Access Compliance Report Public Rights-of-Way (Curb Ramps)

Intersection ID: 3985 Main Street: ARMITAGE DR **Cross Street: ARMITAGE DR** Location: W **ADA ID: F32EDF16EBEF** Ramp Type: Directional1 Initial Pass/Fail: Pass **Overall Compliance: No Severity Score:** 15

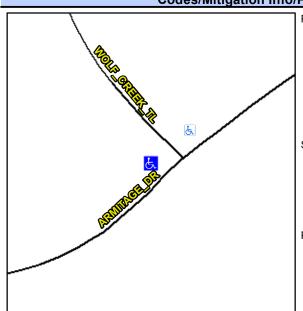
WOLF CREEK TL Street 1 Name Stop Condition-Street 1 StopSign Street 2 Name N/A Stop Condition-Street 2 N/A Possible Solutions: Remove & Replace Entire Ramp. Remove & Replace Gutter. Surveyor Notes: N/A PROW/ADA: Not Found, R304.2.2-Perp, R304.3.2-Para, R304.5.3, R304.5.2, R305.2, R302.7.2

| Field Measurements/Component Compliance | | | | | |
|---|-----------------------|-------|------|-----------------------------|------|
| No | Landing Slope (%) | 4.4 | Yes | DWS Length (in) | 25.5 |
| No | Landing X Slope (%) | 2.9 | Yes | DWS Full Width? | Yes |
| No | Gutter Lip Ht (in) | 1.5 | No | Gutter X Slope (%) | 7.1 |
